FINAL PLAT OF MEADOW CREEK

AN ADDITION TO WICHITA, SEDGWICK COUNTY, KANSAS

Re: S/D 94-33 - Meadow Creek Addition (Final Plat)

CASE NUMBER: S/D 94-33 MEADOW CREEK ADDITION

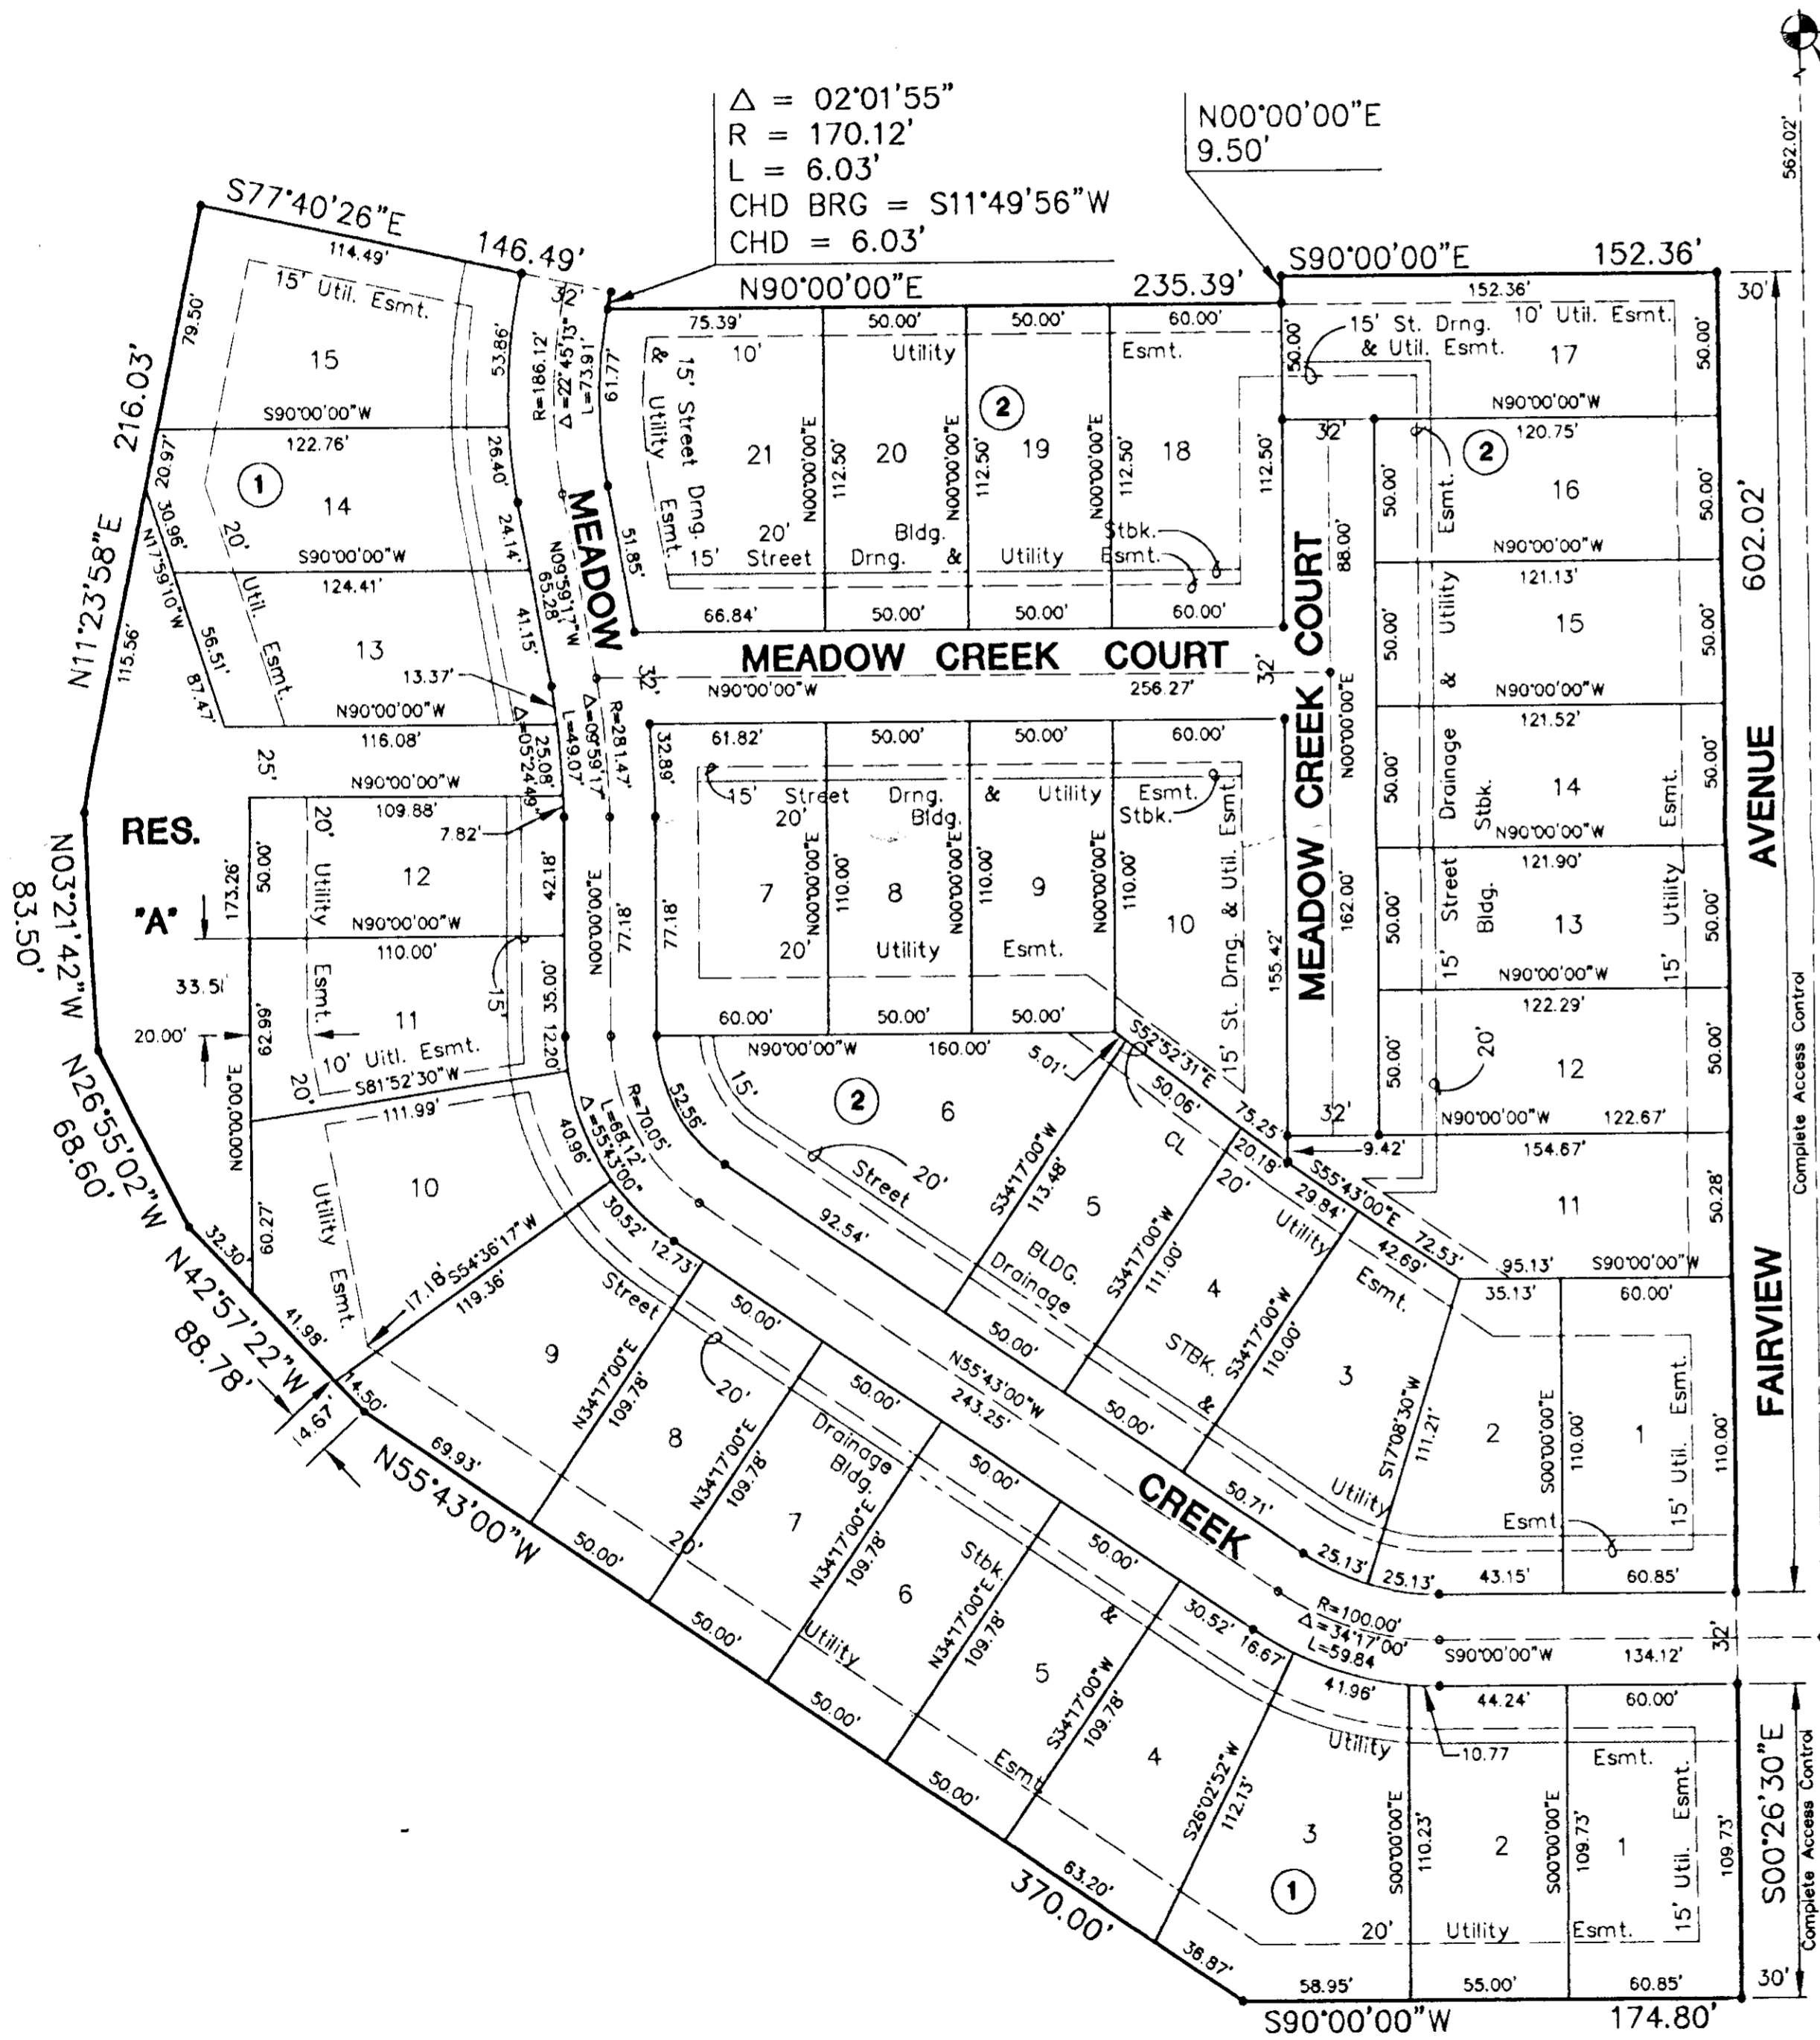
- ~~E.~~ The applicant shall guarantee the paving of the narrow public streets to the 29-foot paving standard. This guarantee shall also provide for a temporary turnaround in the area of Lot 15, Block 1. It is recommended that the right-of-way be provided off-site by separate instrument or if possible included as part of this plat.

- G. As determined appropriate, the final plat tracing shall indicate easements or Reserves along the west line of this plat for public access. In particular, it appears that Reserve A could/should be extended along the rear of the lots north of this Reserve. For the lots to the south of the Reserve, the applicant should determine with the Park's Department and Planning if sufficient area already exists along the Canal for any such access trails.

- K. On the final plat tracing, the 20-foot building setback to Meadow Creek on Lots 13, 14 & 15, Block 1 shall be labeled.
- L. On the final plat tracing, the MAPC Chairman shall be shown as James D. Miner and Pat Burnett shall be indicated as the "Deputy City Clerk".

- Q. As indicated by City Engineering, minimum building pad elevations are to be shown for this site. Such elevations are needed for all lots adjacent to the canal and shall be properly indicated on the final plat tracing.
